FDOT INDEX #200/201 STORM MANHOLE # S-106

FDOT 434986-1-52-01

STRAIGHT AHEAD CONSTRUCTION

10960723S-106.idw

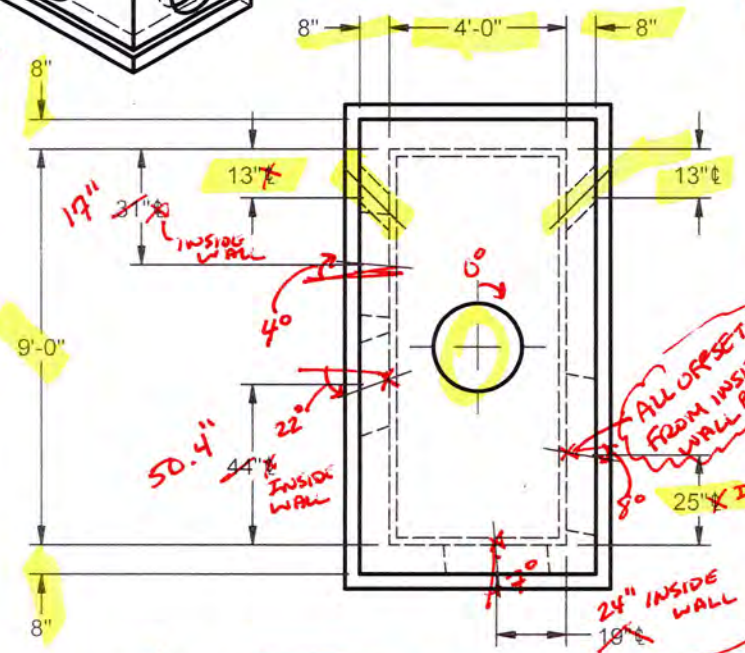
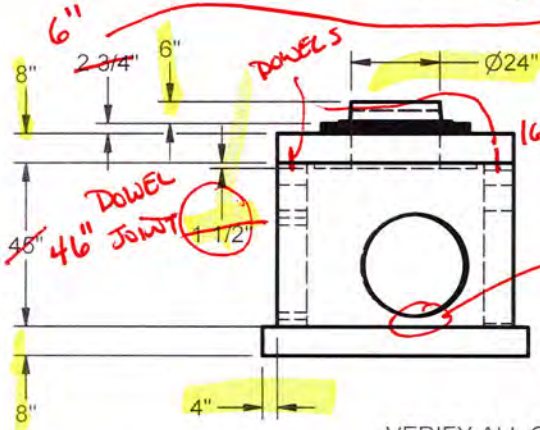
DUE TO NOT HAVING 6" OF CONCRETE ABOVE THE HOLE OPENINGS IN WALL, FDOT WILL REQUIRE THIS SHOP DRAWING TO BE APPROVED BY THE EOR PRIOR TO MANUFACTURE.

FG =	164.28
TA =	163.78
TTS =	~~163.55~~ 163.28
TPW1 =	~~162.88~~ 162.62
ITB =	~~159.13~~ 158.80
APTB =	~~4.65~~ 4.98

VERIFY ALL OFFSETS

PC #	WEIGHT	PIECE DESCRIPTION	PRODUCT CODE
		PER INDEX 201 SHEET 3 OF 5, INCREASING THE UP ELEVATION TO 6" (HOLE RISE) ALLOWS THE CONCRETE ABOVE THE HOLE OPENING TO BE ZERO, USING DOWEL JOINTS.	
		INCREASE ADJUSTMENT TO STAY OUT OF CONCRETE ROAD TOP OF PIPE WILL BE CLOSE TO ~~BOT~~ BOTTOM OF 8" SLAB (0" BLANKOUT ON TOP OF 30" RCP)	
2	5734 (30" RCP	048L x 108W x 08Wall x 08H, TopSlab	SS08408408S008N
1	15105	048L x 108W x 08Wall x 045H, MonoBaseExt	SS08408408B048X

PC #	DEG/ DIR	PIPE SIZE	PIPE INVERT	HOLE SIZE (INSIDE WALL OFFSET)	BOOT TYPE	HOLE INVERT	HOLE RAISE
1	E	4 PVC	162.00	7H x 18W (C/L 13 Off N Wall)	NONE	161.88	~~33"~~ 37"
1	E 98°	30 RCP	159.80	42 (C/L 25 Off S Wall)	NONE	159.3	~~2"~~ 6"
1	S 193°	18 RCP	159.80	28 (C/L 19 Off E Wall) 24"	NONE	159.38	~~3"~~ 7"
1	W 248°	18 PVC	159.93	24 (C/L 44 Off S Wall) 50"	NONE	159.68	~~6 1/2"~~ 10 1/2"
1	W 274°	18 RCP	159.80	28 (C/L 31 Off N Wall) 17"	NONE	159.38	~~3"~~ 7"
1	W	4 PVC	162.00	7H x 18W (C/L 13 Off N Wall)	NONE	161.88	~~33"~~ 37"

INSURE NOT CONFLICT W/ 18" RCP
